**From:** Rob Ewing <REwing@danville.ca.gov>  
**Sent:** Monday, July 12, 2021 10:27 AM  
**To:** Clerk of the Board; Sean Tully  
**Cc:** Joe Calabrigo  
**Subject:** Submission for Board Agenda Item D.4-Tassajara Parks  
**Attachments:** Danville letter to BOS-with attachments.pdf

Re: Tassajara Parks Project—General Plan Amendment (CDGP07-0009); Rezoning (CDRZ09-3212); Vesting Tentative Tract Map (CDS10-9280); Development Plan and Development Agreement (CDDP10-3008)—Support for Project Denial

On behalf of the Town of Danville, I submit all prior comments and additional new comments regarding the Environmental Impact Report ("EIR") prepared by Contra Costa County pursuant to the California Environmental Quality Act ("CEQA") (Pub. Resources Code, §§ 21000 et seq.; Cal. Code Regs., tit. 14, §§ 15000 et seq. [CEQA Guidelines]) and related land use entitlements for the Tassajara Parks Project ("Project") and suggested findings that support the Board of Supervisor's ("Board") denial of the Project. We encourage the Board to review this letter closely, along with the Town's prior letters and other documents attached hereto, and follow the recommendation of its Planning Commission, and

Figure 1: Chart illustrating the need for local reductions to meet CAP goals

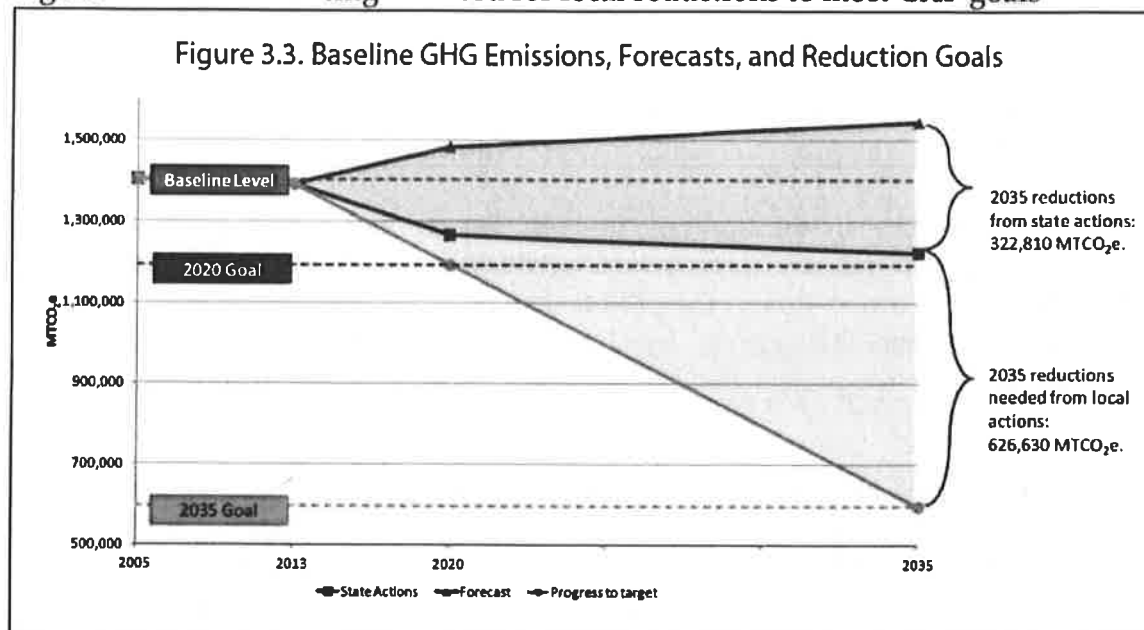
While the project may be fully constructed by 2020 (and even that seems quite ambitious), the project will not be "complete" until the end of its operational lifespan, which is calculated to be 30 years. (RDEIR, p. 3.3-66.) As stated in our July 2016 comments, virtually all of the project's operational emissions would occur between 2020 and 2050. These emissions represent the vast bulk of the project's GHG emissions and cannot be excused without mitigating them to the fullest extent feasible.

Moreover, there are two applicable post-2020 GHG reduction targets against which the project could measure its operational (and annualized construction) emissions. The first is SB 32—the California Global Warming Solutions Act of 2006, which Governor Brown signed into law on September 8, 2016. SB 32 is a "legislative mandate" to reduce GHG emissions by 40% below 1990 levels by 2030. (Legis. Council's Dig., Sen. Bill No. 32, (2015-2016 Reg. Sess.) Chapter 249; SB 32 available at [https://leginfo.ca.gov/faces/billNavClient.xhtml?bill\\_id=201520160SB32](https://leginfo.ca.gov/faces/billNavClient.xhtml?bill_id=201520160SB32) (last visited Nov. 4, 2016).) The EIR must analyze the Project's consistency with this target, which applies to both the project's construction and operational emissions. The second applicable post-2020 target is the CAP's 2035 GHG emissions reduction target of 50% below 1990 levels, or 57% below the 2005 baseline level. (Contra Costa County Climate Action Plan, #3, p. 37 (Attachment B).) The CAP goes beyond setting the overall target for 2035, and establishes the amount of "reductions needed from local actions" to meet the 2035 target. (*Id.* at p. 38, see Figure 1.) As Figure 1 illustrates, there is great need for reductions from local actions in addition to any anticipated reductions from state actions. The RDEIR must analyze the project's consistency with this target as well.
